Exhibit 3-1
Access & Circulation Plan

Exhibit 3-2
Four Lane Arterial Street Cross Section

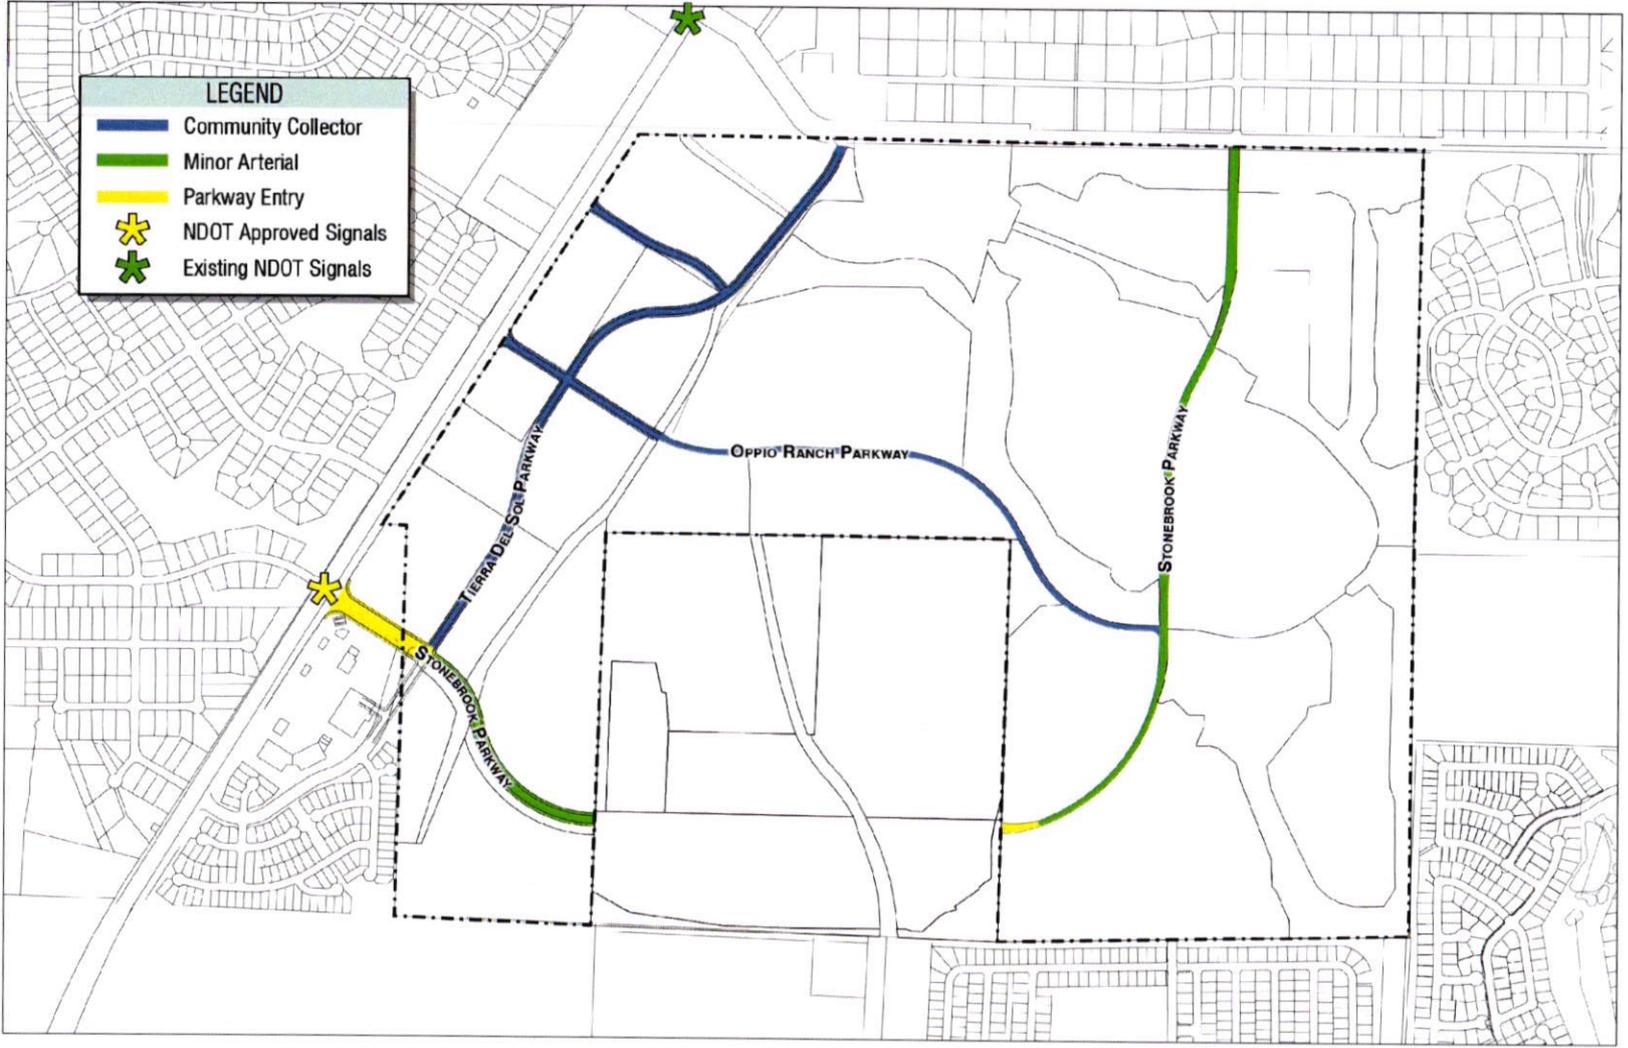
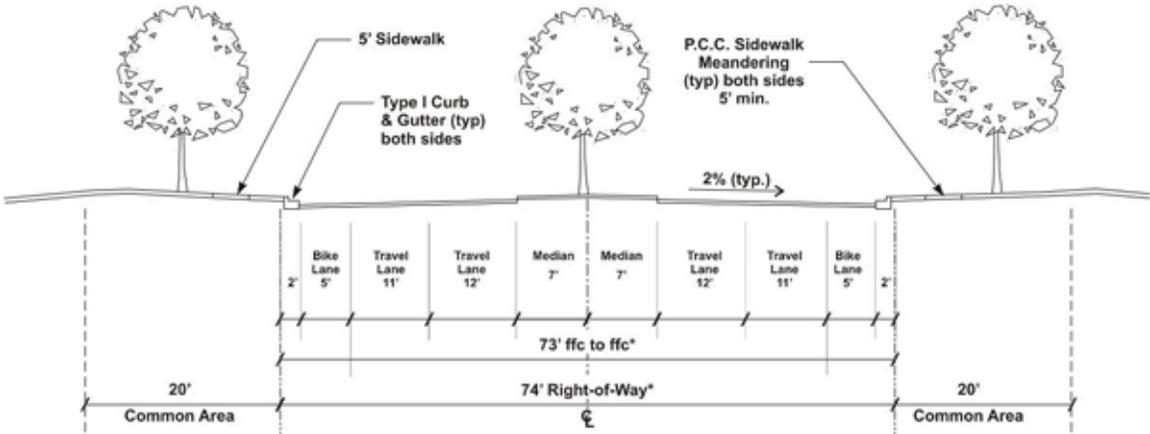
Proposed Change

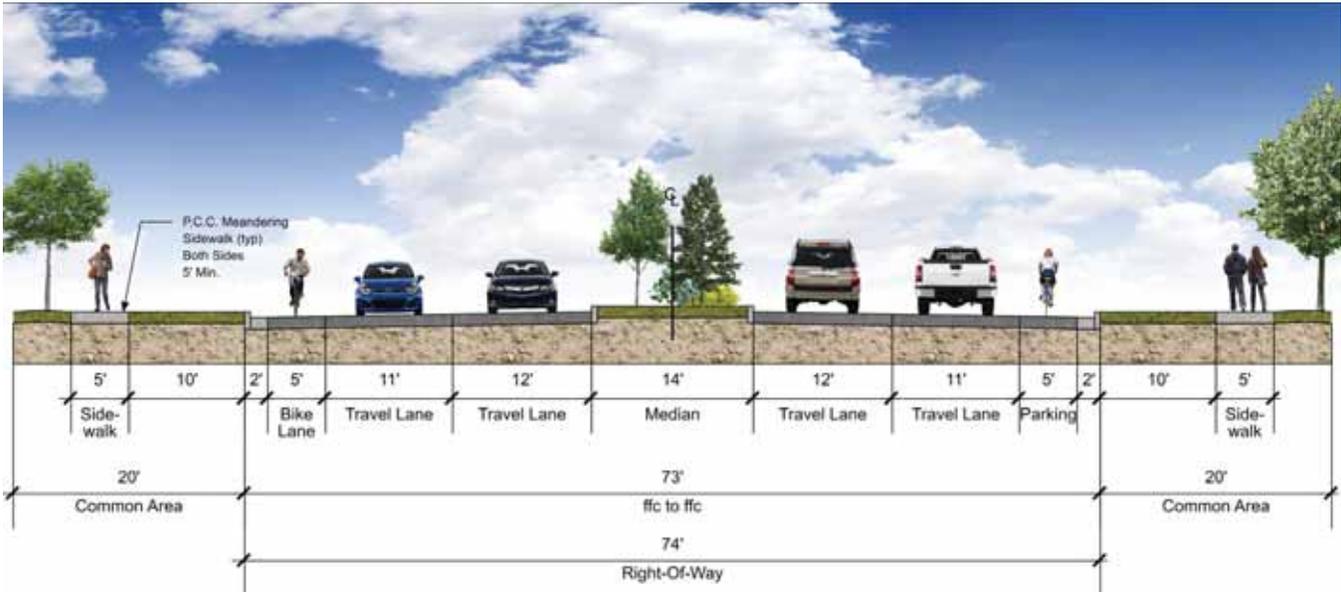
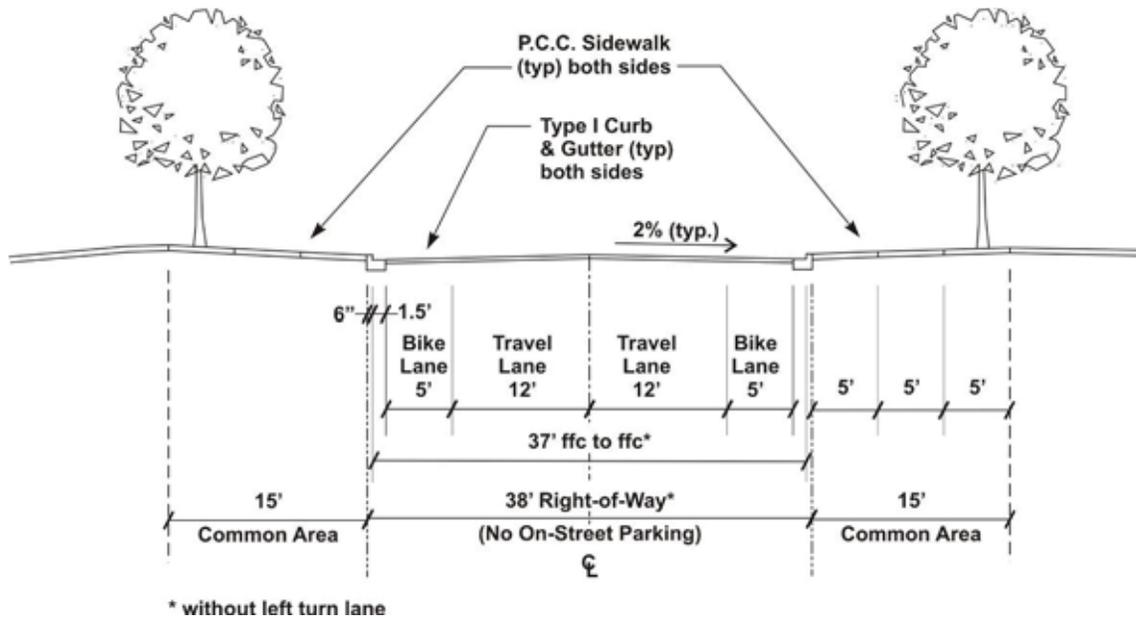
- Without Left Turn Lane
- Landscape Areas depicted along and within ROW to be installed at the time of roadway construction per the standards of the Landscape Section, Chapter 10, and shall be maintained by a. Stonebrook Maintenance Association.
- No direct residential access or on-street parking allowed.

Proposed Change

Exhibit 3-3
Two Lane Arterial Street Cross Section

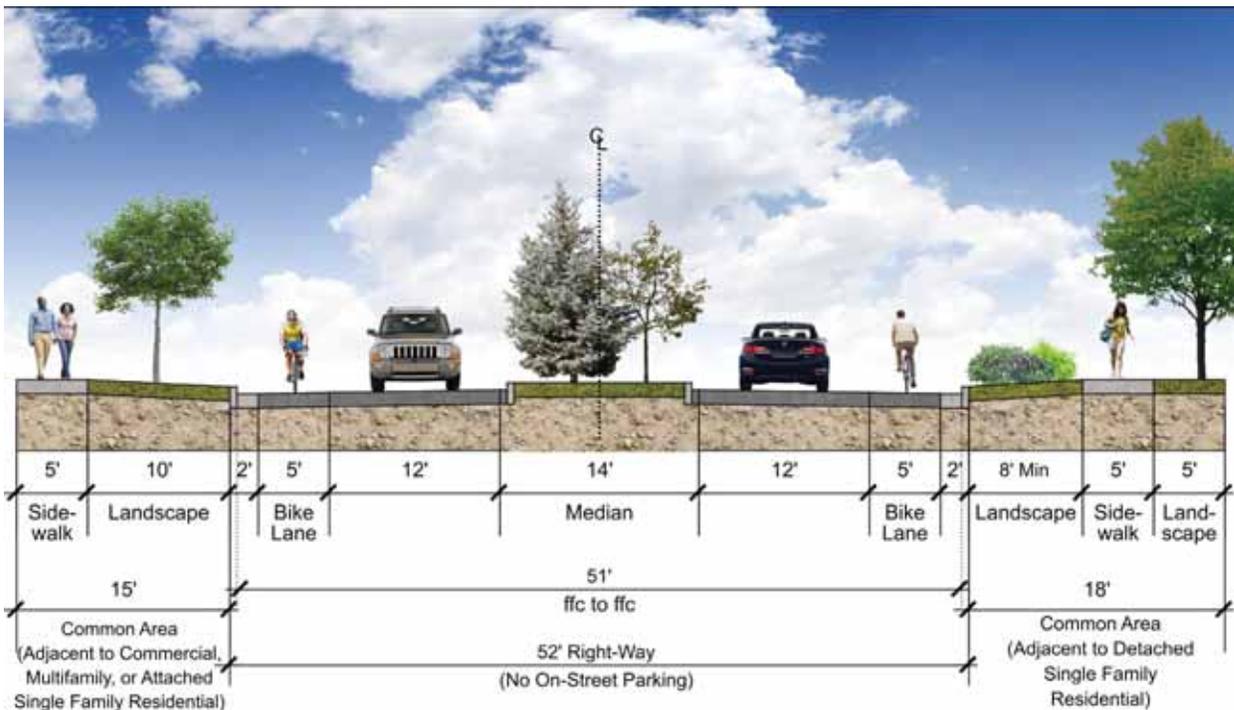
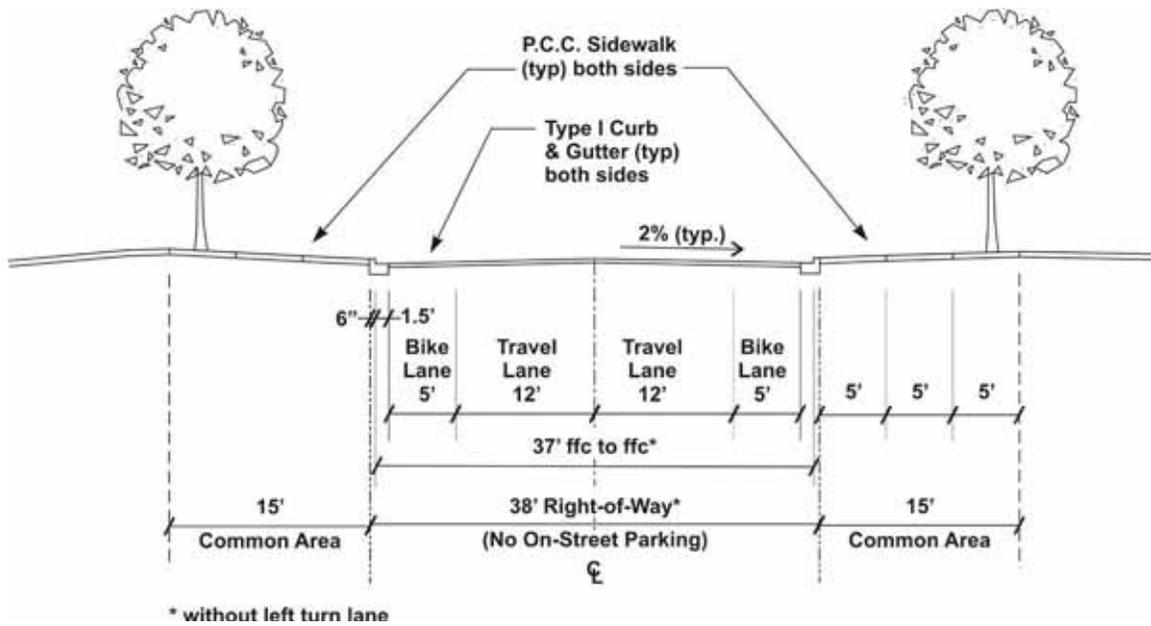
- Landscape Areas depicted along and within ROW to be installed at the time of roadway construction per the standards of the Landscape Section, Chapter 10, and shall be maintained by a Stonebrook Maintenance Association.
- No direct residential access or on-street parking allowed.

Proposed Change

Exhibit 3-4
Community Collector Street Cross Section

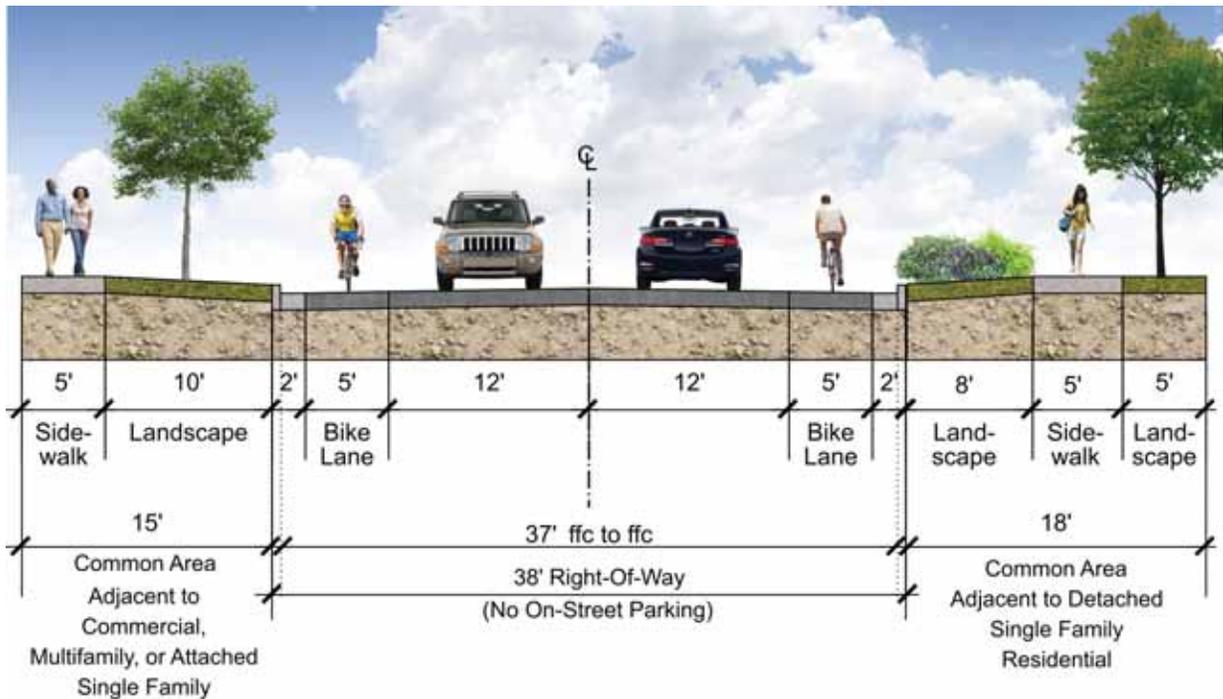
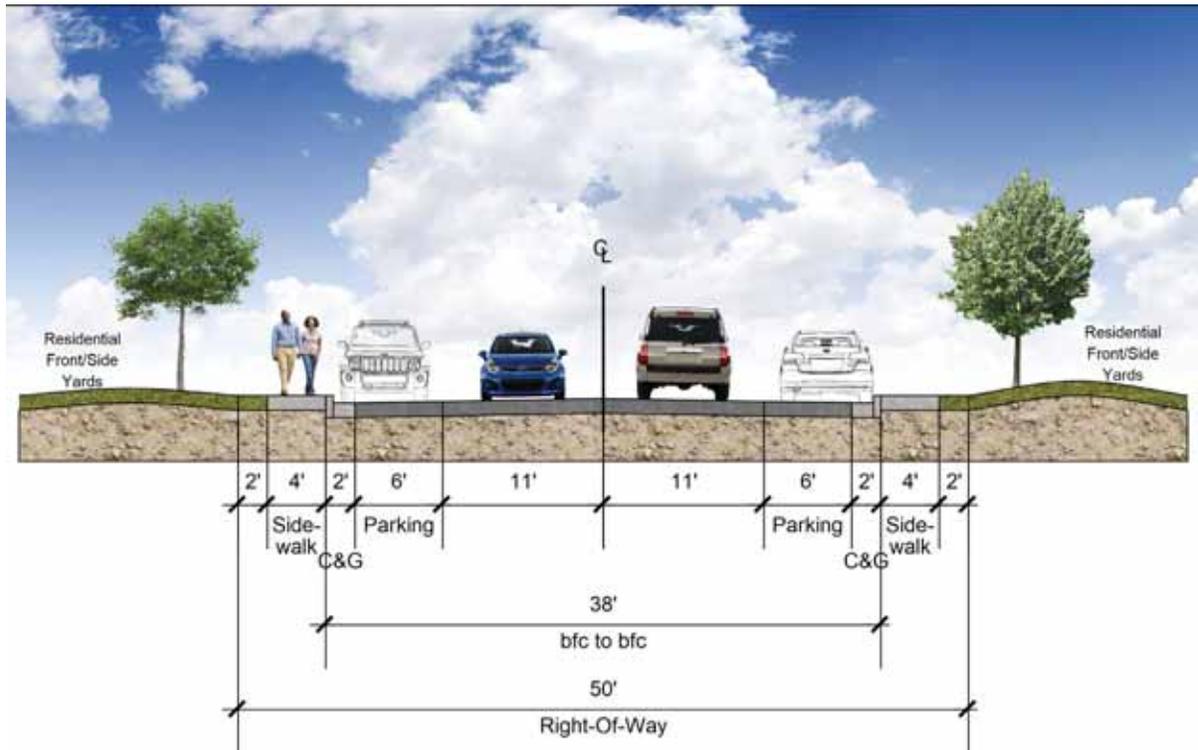
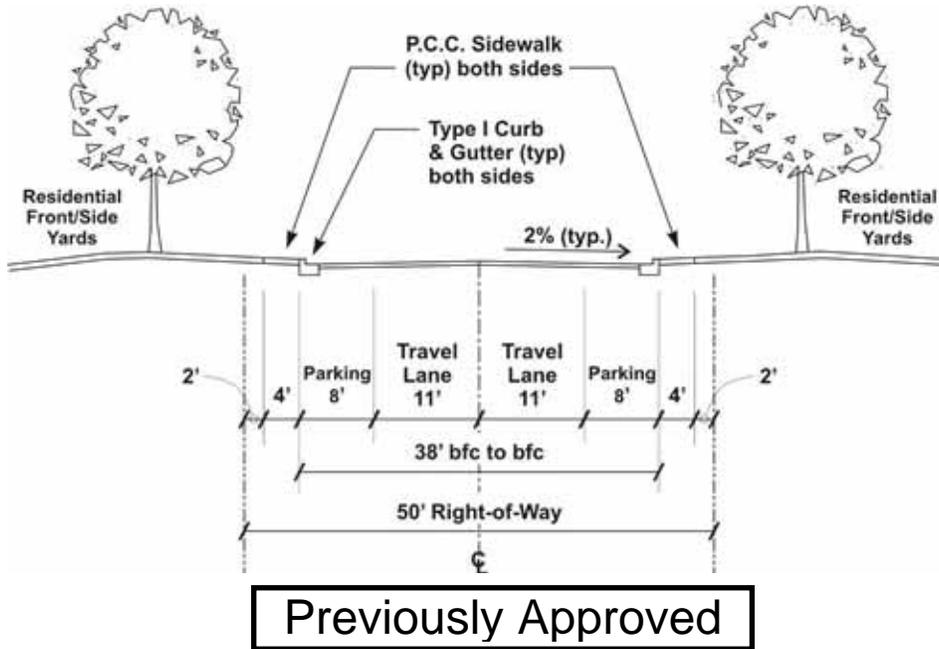
- Landscape Areas depicted along and within ROW to be installed at the time of roadway construction per the standards of the Landscape Section, Chapter 10, and shall be maintained by a Stonebrook Maintenance Association.
- No direct residential access or on-street parking allowed.
- Oppio Parkway shall include a continuous center left turn lane.

Proposed Change

Exhibit 6-1
Multi-Family - 8 Plex Conceptual Illustration

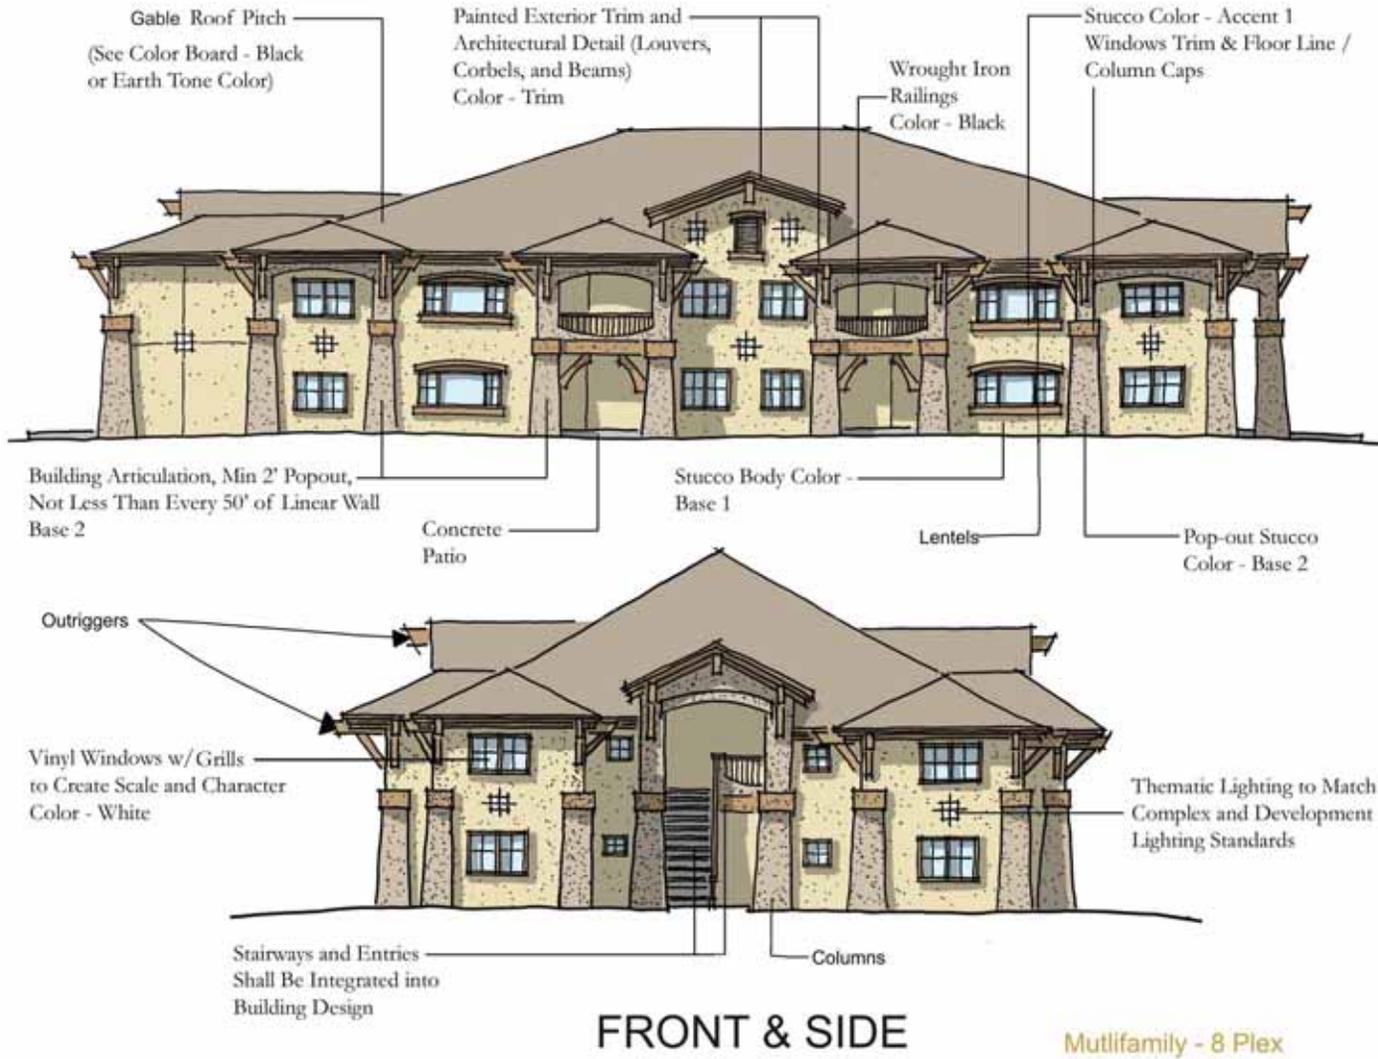
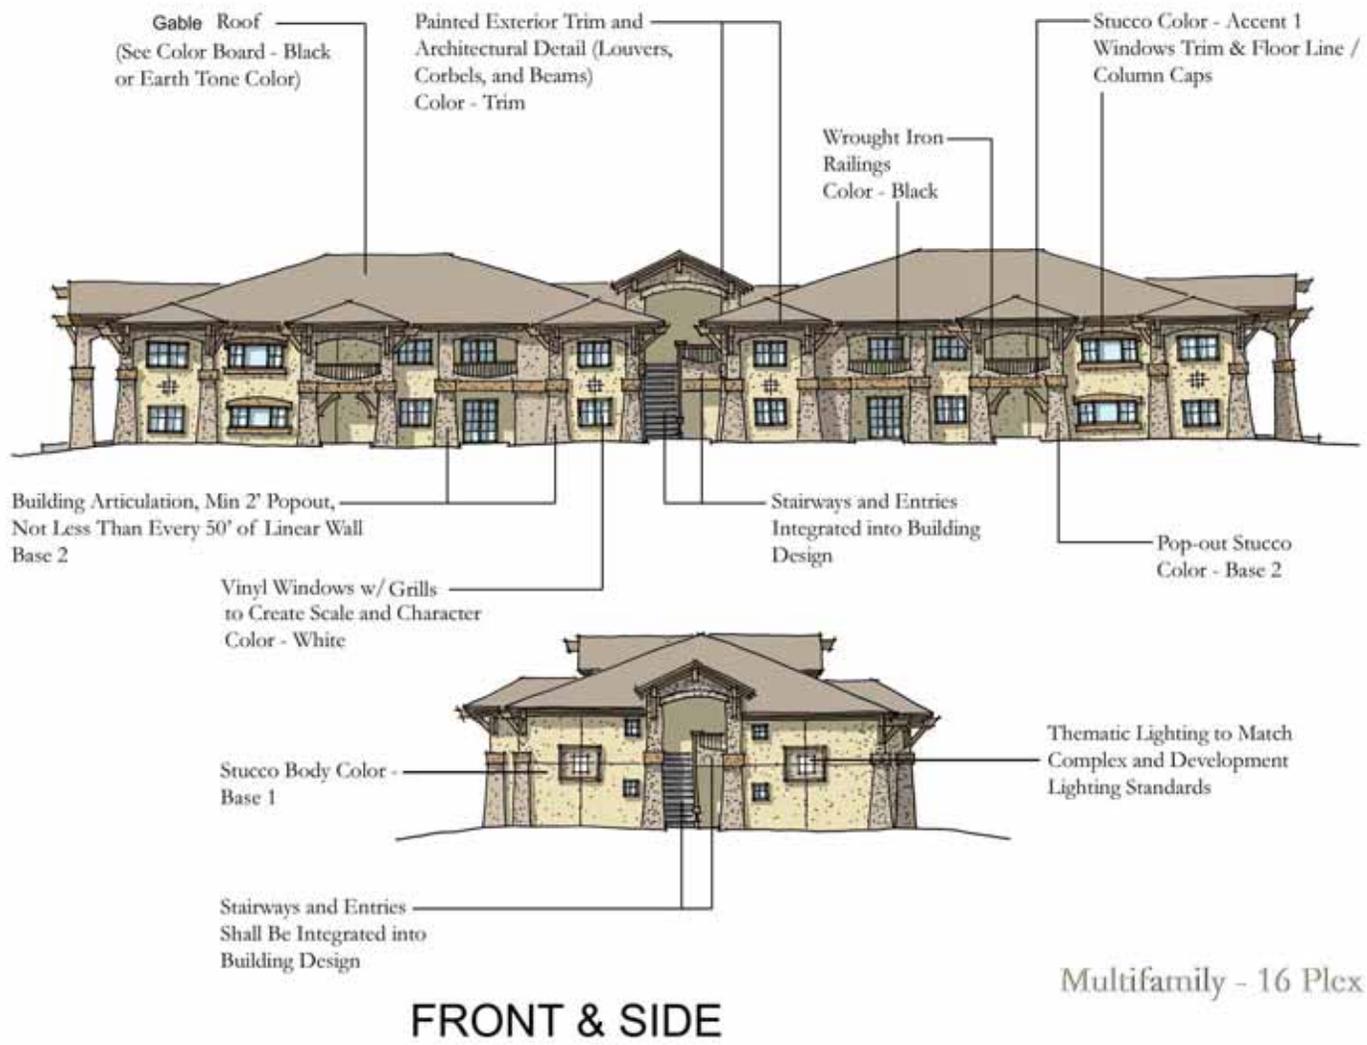
Proposed Change
